BIBBO ASSOCIATES, L.L.P.

September 13, 2021

RE: Subdivision & Site Plan Approval Bedford EMP Ownership, LLC - Robert Morse 50 East Middle Patent Road North Castle (T)

Our office has revised our plans pursuant to the July 6, 2021, Staff Report prepared by the Town Planner and the July 9, 2021, memorandum prepared by Kellard Sessions, Consulting Town Engineer. We offer the following responses for the Board's consideration:

3-202	1 TOWN COMMENTS			RH/MG
TE:	DESCRIPTION			BY/CK
NT	FROL PLAN	DATE:	9-13-202	21
DT 2		SCALE:	1" = 30'	
SIO		FILE:	1-E	
OAD WESTCHESTER COUNTY		DSGN / CHK:	MG	
		DRN. BY:	RH	
~~ ~		SHT NO.	2 OF 4	
0 SUI	DCIATES, LLP TE 203 RK 10589	DWG NO.	EC	-1

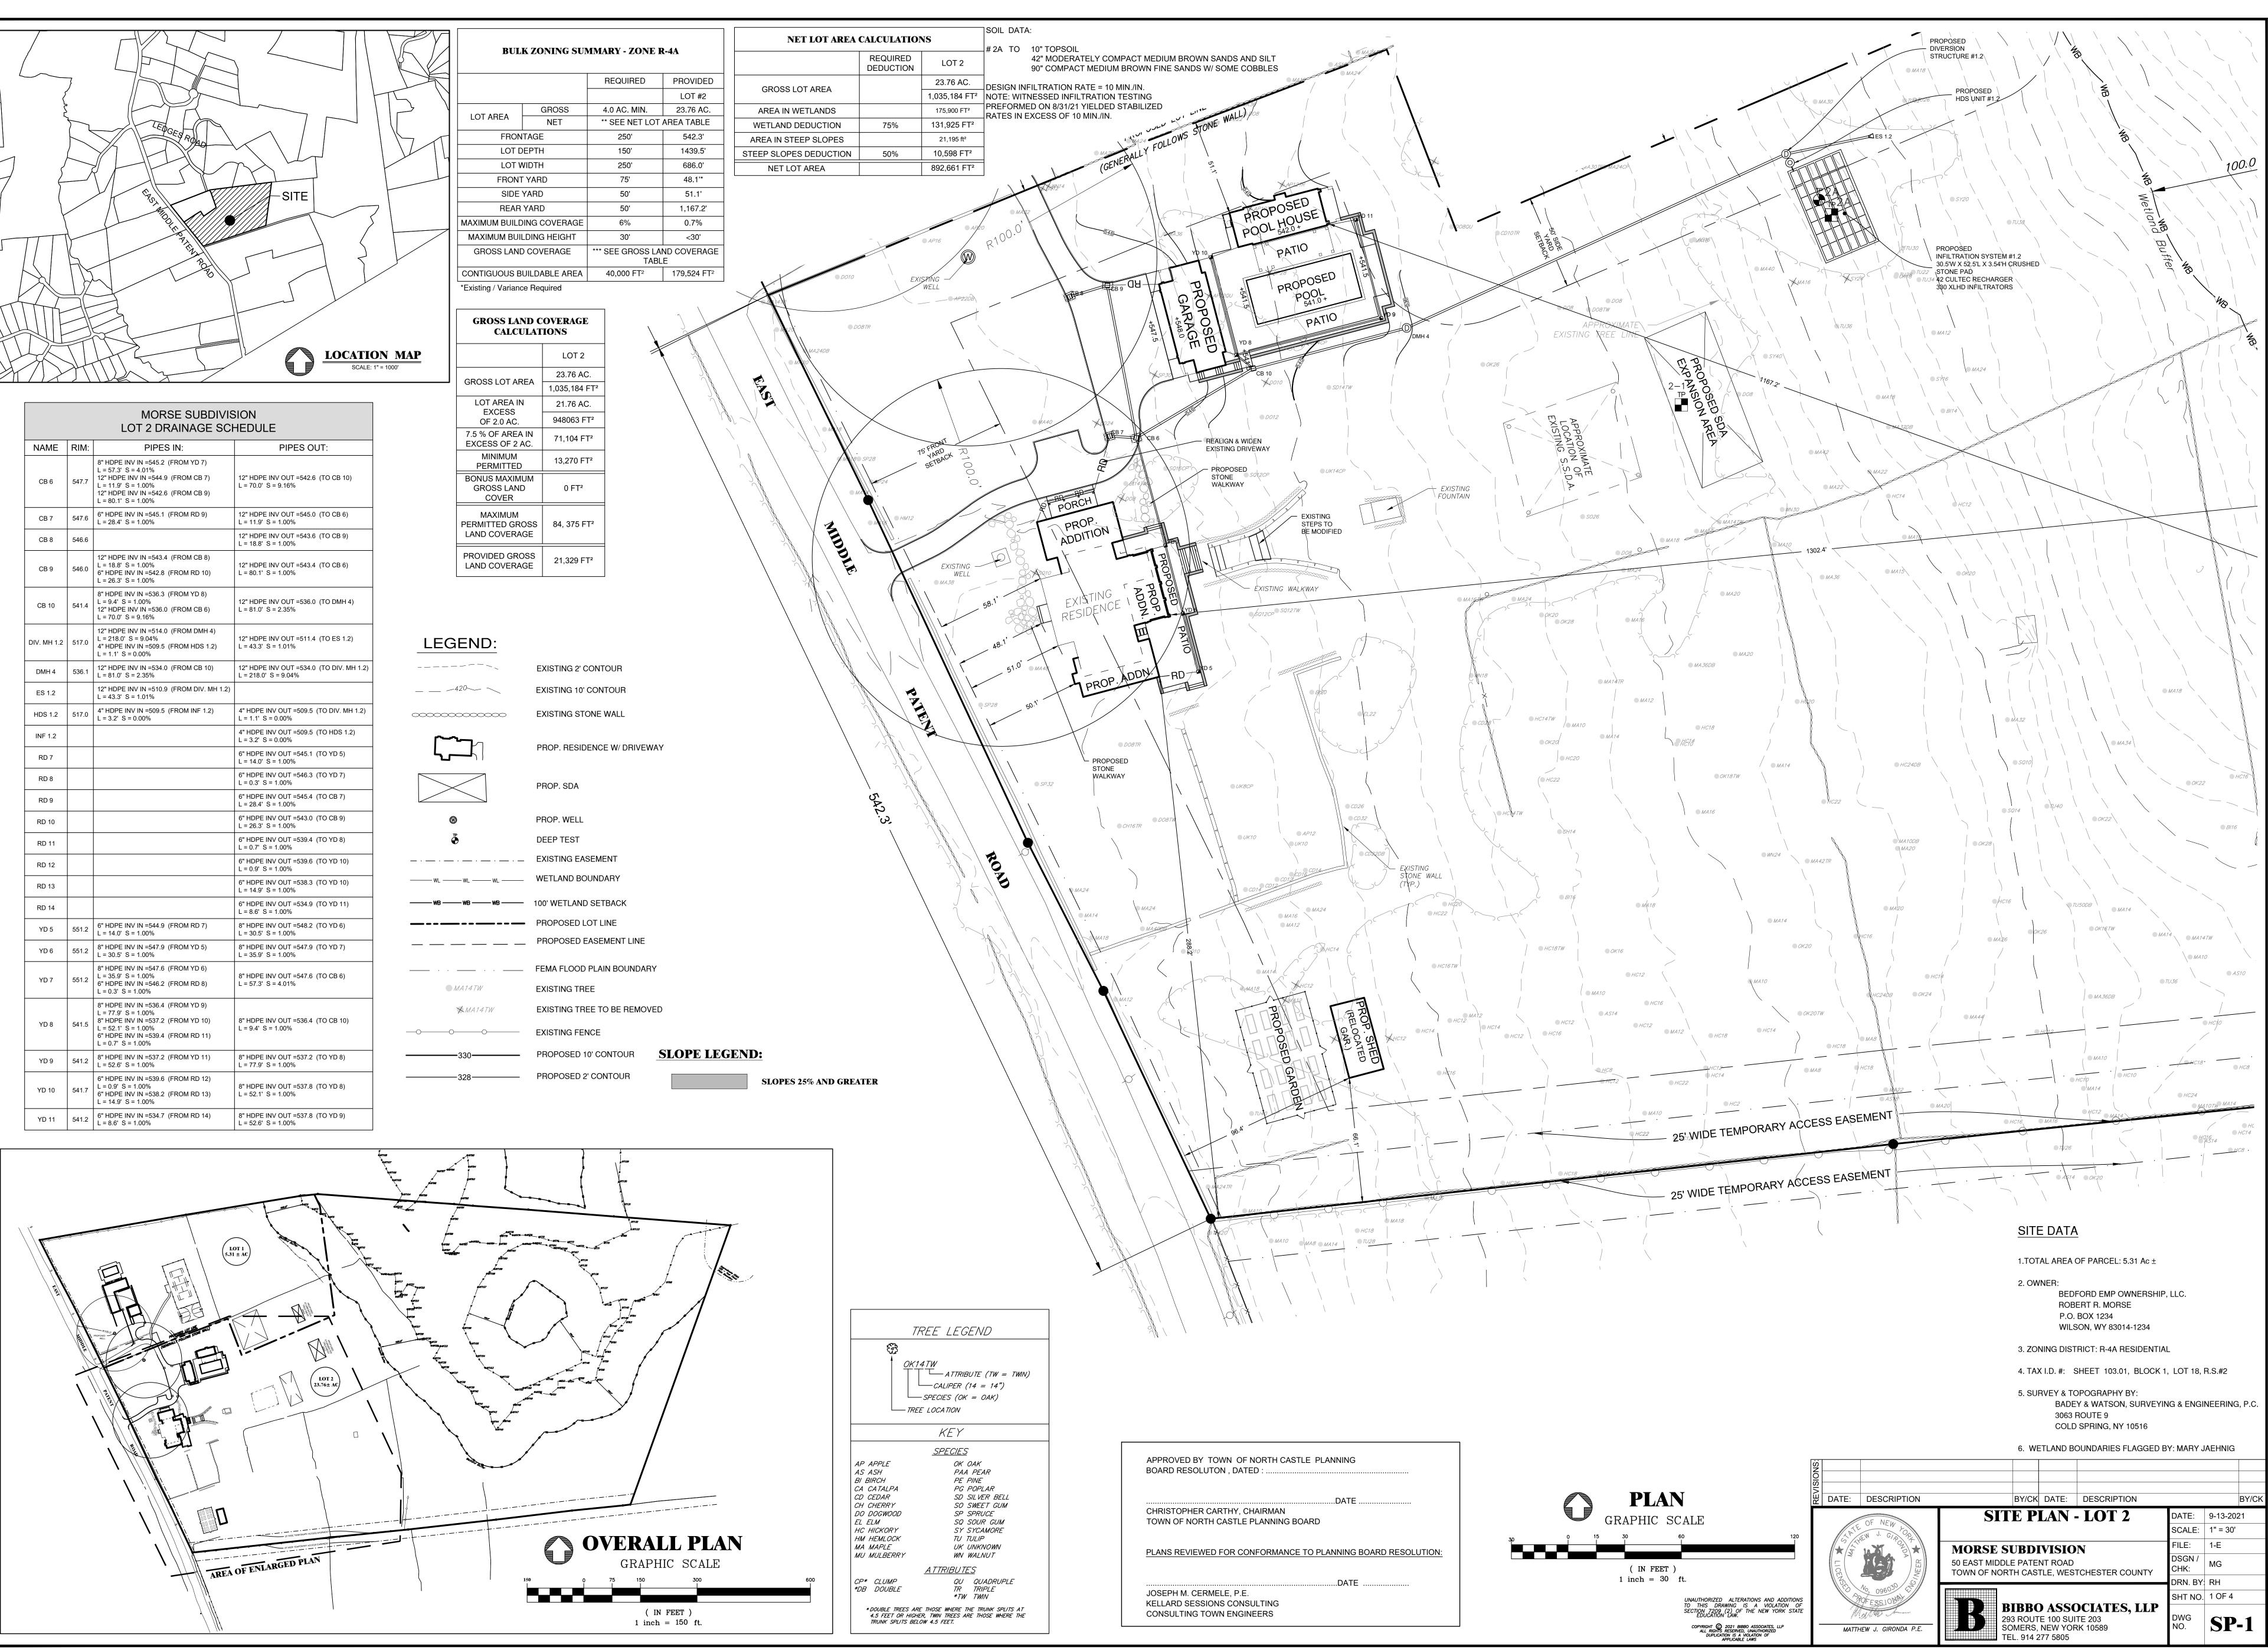
- 15. No outdoor lighting is proposed for the existing tennis and sport courts.
- 16. Proposed site grading for lot 1 is shown on the project site plans, and the limits of proposed disturbance are quantified on the Erosion and Sediment Control Plans.
